Project	IEEE 802.16 Broadband Wireless Access Working Group < http://ieee802.org/16 >	
Title	MIH C-SAP Primitives	
Date Submitted	2006-03-09	
Source(s)	David Johnston Intel Corporation 2111 NE 25th Ave Hillsboro, OR, 97006 USA	Voice: +1 503 264 3855 Fax: +1 503 264 3483 dj.johnston@intel.com
Re:	Doc IEEE 802.16g-D1	
Abstract	Provides the missing C-SAP primitives to carry the MIH 802.21 Frames.	
Purpose	To enable the carriage of 802.21 MIHF frames over the C-SAP to be mapped onto the 802.21 MIH-SAP.	
Notice	This document has been prepared to assist IEEE 802.16. It is offered as a basis for discussion and is not binding on the contributing individual(s) or organization(s). The material in this document is subject to change in form and content after further study. The contributor(s) reserve(s) the right to add, amend or withdraw material contained herein.	
Release	The contributor grants a free, irrevocable license to the IEEE to incorporate material contained in this contribution, and any modifications thereof, in the creation of an IEEE Standards publication; to copyright in the IEEE's name any IEEE Standards publication even though it may include portions of this contribution; and a

Figure 504—MIH Primitive Flow between 802.16 Entity and NMCS for 802.21 Support

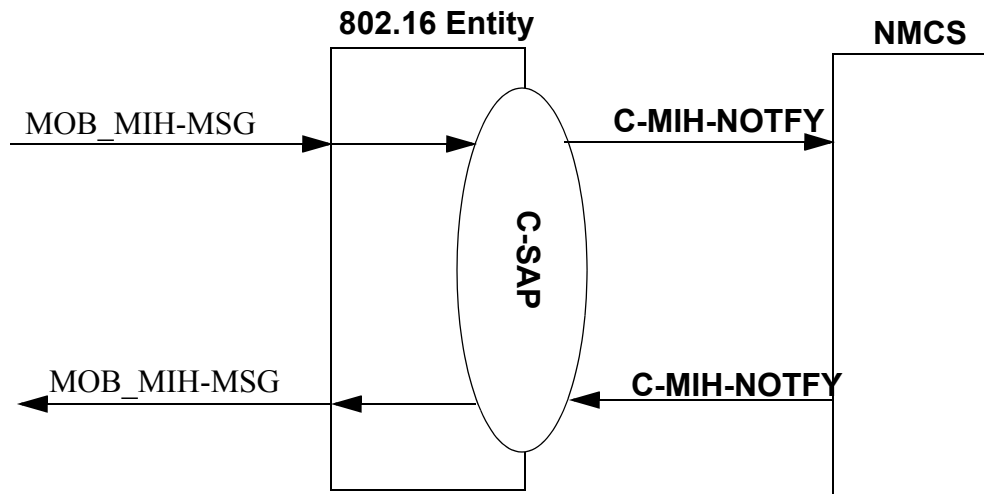
Insert new text into 802.16g, 14.2.9.8:

The MIH Control Primitives provide carriage of 802.21 MIHF Frames between the 802.16 entity and the NMCS. This enables the NMCS to map between MIHF frames and primitives on the 802.21 MIH-SAP, consistent with Clause 5.5.3 of IEEE Std 802.21.
